MEMORANDUM

Reference: Colony Park PUD Traffic Impact Analysis Update (C814-2014-0110.SH) – Final Memo

Figure 2. Improvement details

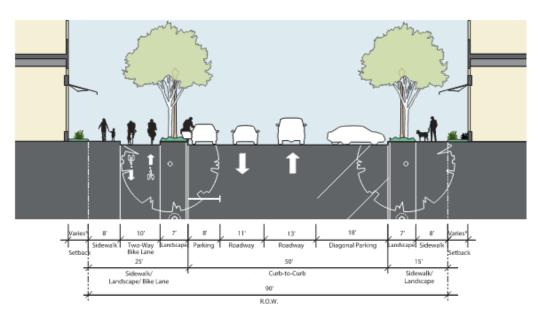
Table 2. Required Improvements (Construction)					
Name	Improvement	Developer's Share			
Colony Loop Dr Construction (See Figures 2 & 3 for the improvement extent)	Design and construct the missing Colony Loop section from Overton Elementary School to Valleyfield Drive	100%			
Wilmington Dr Construction (See Figures 2, 4, & 5 for the improvement extent)	Design and construct Wilmington Dr from Loyola Lane to Colony Loop Drive	100%			
Colony Loop Drive/Cielo Vista Drive and Loyola Lane (See	Design and construct a traffic signal*	100%			
Figure 2 for the improvement extent)	Restriping of southbound approach. The lane configuration for the southbound approach at the intersection shall be a left/thru lane plus a right-turn lane.	100%			
Colony Loop Drive and	Design and construct a traffic signal**	100%			
Decker Lane (See Figure 2 for the improvement extent)	Restriping of eastbound approach. The lane configuration for the eastbound approach at the intersection shall be a left-turn lane and a right-turn lane.	100%

Wilmington Drive and Loyola Lane (See Figure 2 for the improvement extent)	Design and construct a traffic signal when warrants are met in the field. The lane configuration for the southbound approach at the intersection shall be a left-turn lane and thru/right lane.	100%

Colony Park Drive and Loyola Lane (See Figure 2 for the improvement extent)	Restriping of southbound approach. The lane configuration for the southbound approach at the intersection shall be a left-turn lane and a right-turn lane.	100%
Wentworth Drive and Loyola Lane (See Figure 2 for the improvement extent)	Restriping of southbound approach. The lane configuration for the southbound approach at the intersection shall be a left/thru lane plus a right-turn lane.	100%
Loyola Lane and Decker Lane (See Figure 2 for the	Construction of a southbound right-turn lane on Decker Lane	100%
improvement extent)	Construction of a westbound right-turn lane on Decker Lake Road	100%
Colony Loop Drive and School/Dwy B (See Figure 2 for the improvement extent)	Restriping of eastbound approach. The lane configuration for the eastbound approach at the intersection shall be a left-turn lane plus thru/right lane.	100%
